PLANNING COMMISSION MEETING
City Hall: 3750 Bridge NW
Wednesday, April 15, 2026 at 7:00 PM

TO: St. Francis Planning Commission
FROM: Beth Richmond and Ryan Kadet, Planners
SUBJECT: Willow Ridge Business Center Site Plan
DATE: 4-8-2026 for 4-15-2026 meeting
APPLICANT: Envision Construction Co, LLC (Garrett Carlson)
LOCATION: Between Cree St NW and St. Francis Blvd NW (PIN 06-33-24-11-0102)
COMP PLAN: Commercial
ZONING: B-2 General Business

RE: Willow Ridge Site Plan Review N0. 1

C1

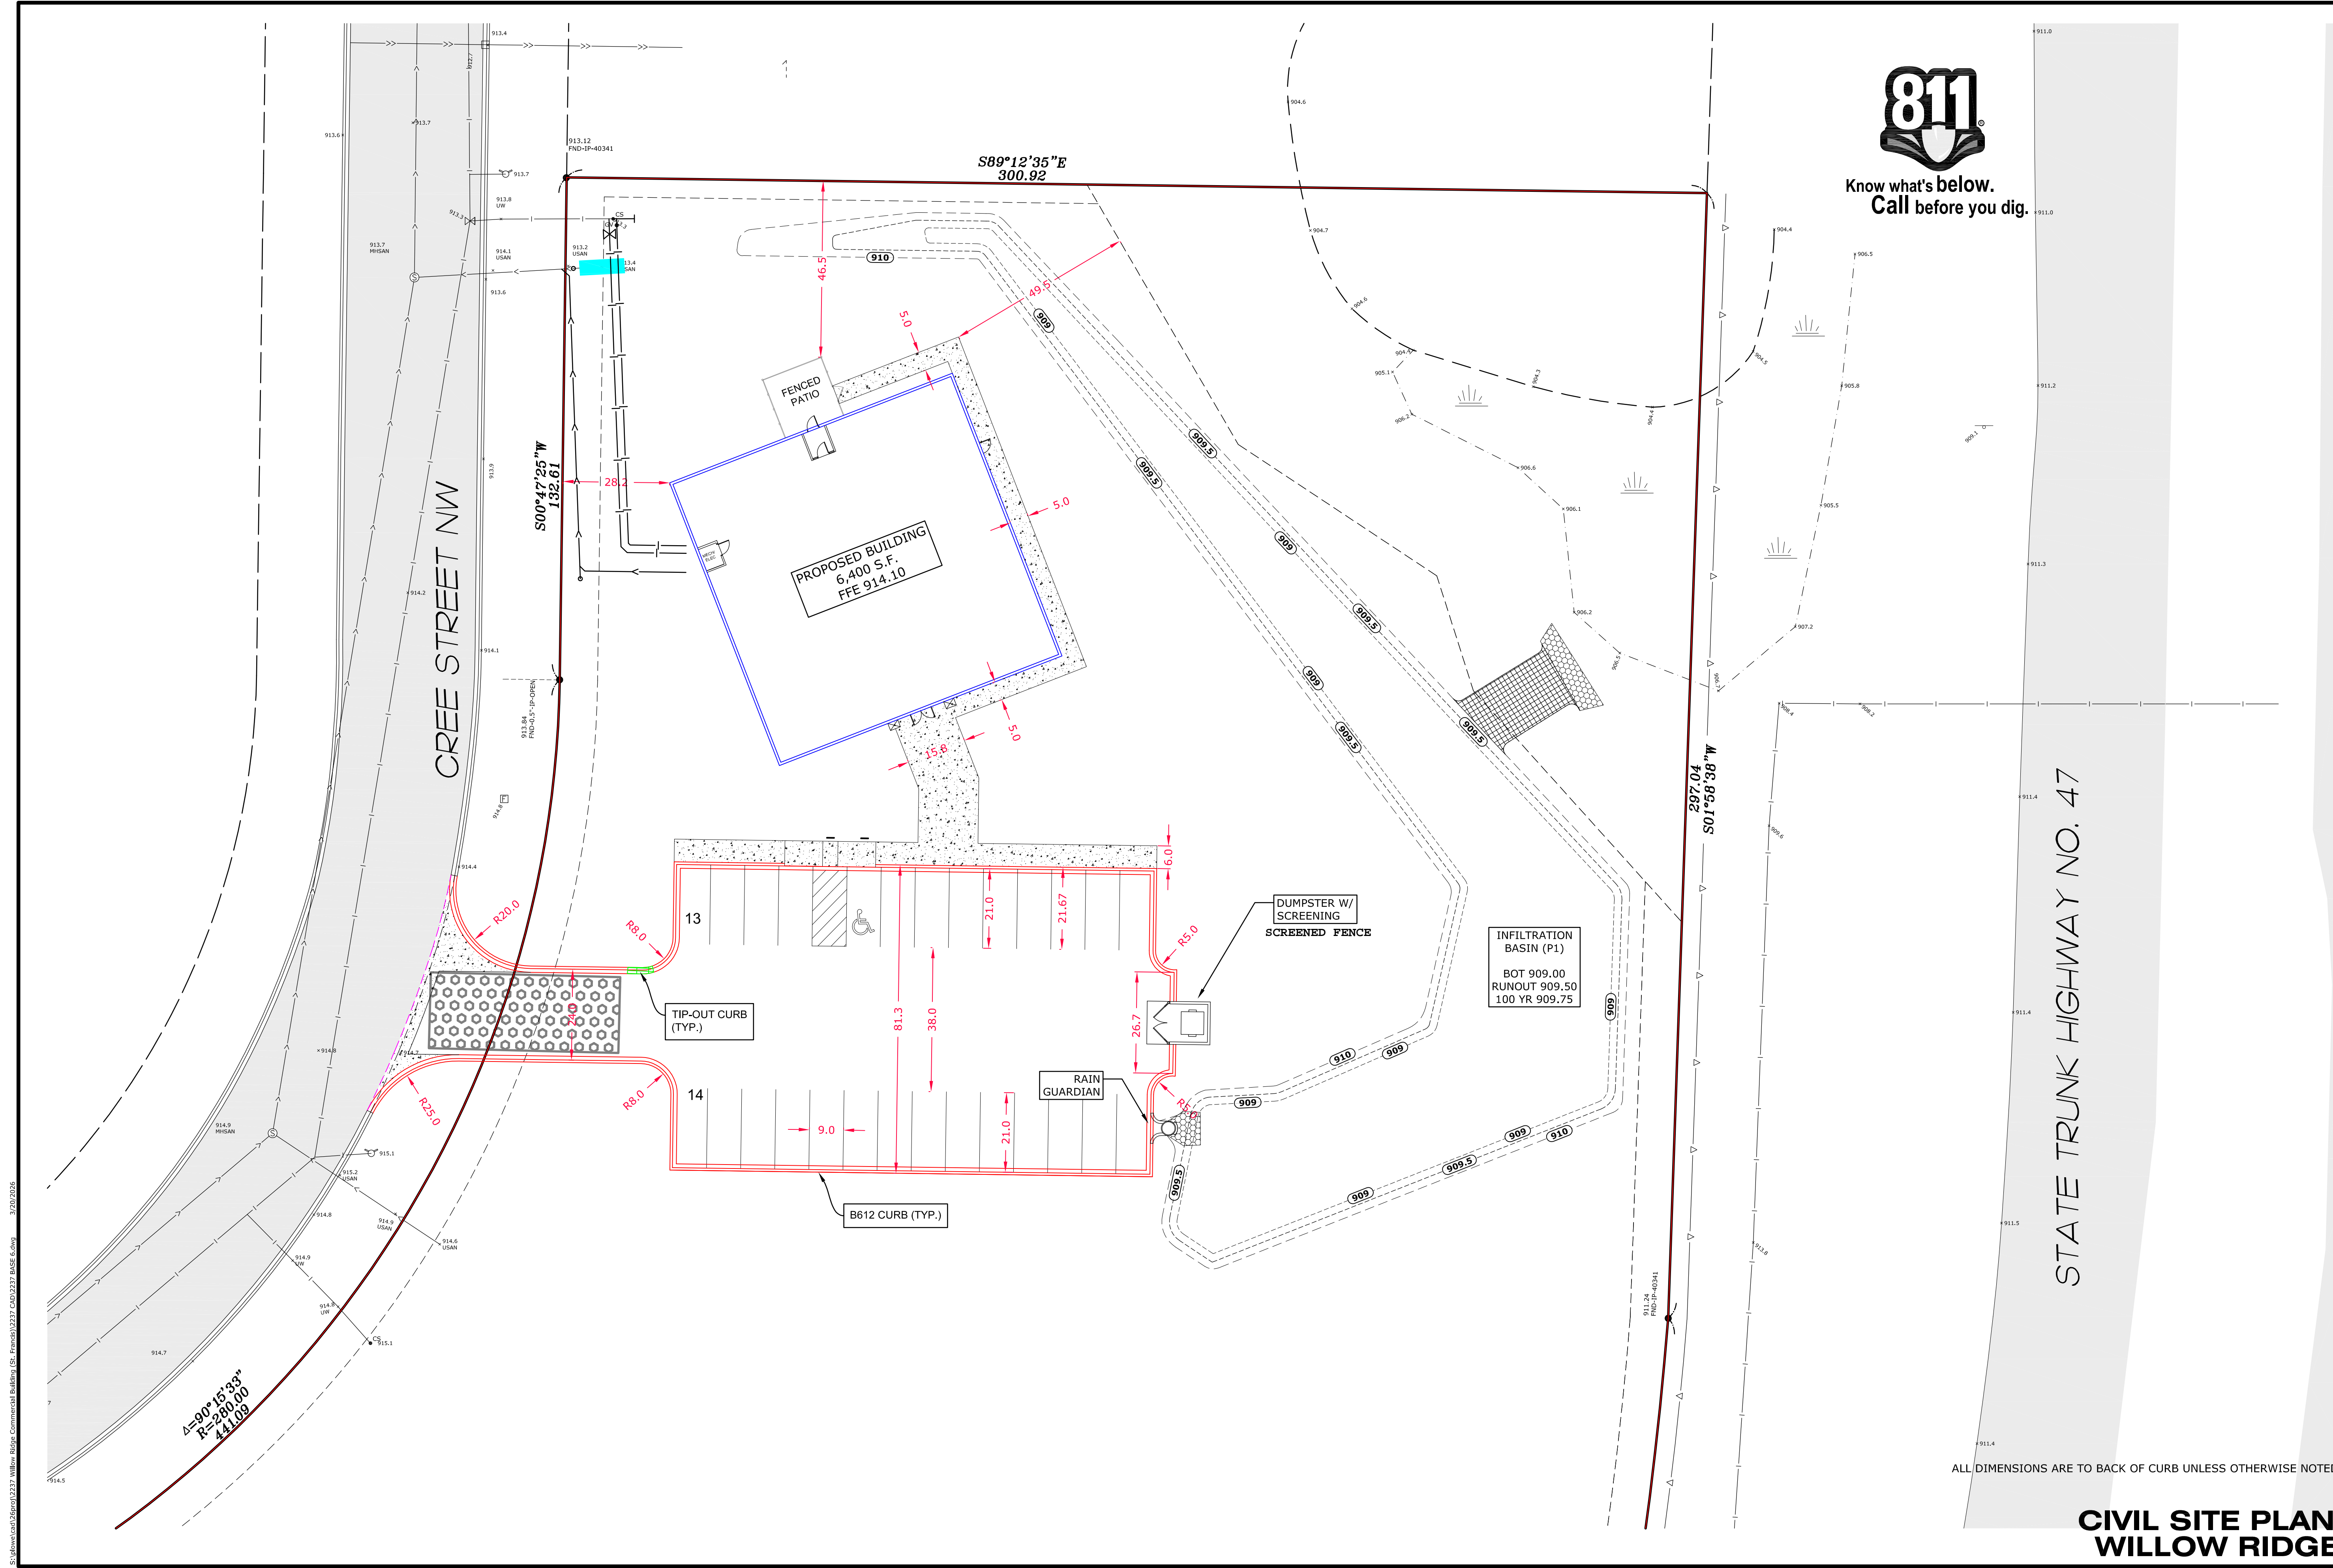
- Clearly label the curb and gutter removal area. All bituminous and curb and gutter shall be sawcut full depth at the match points.
2. Sheet C1
 - Show the building and parking setbacks.

- Label the building dimensions and driveway widths.
 - Show the proposed bituminous and concrete sidewalk hatches in a legend that references the proposed sections.
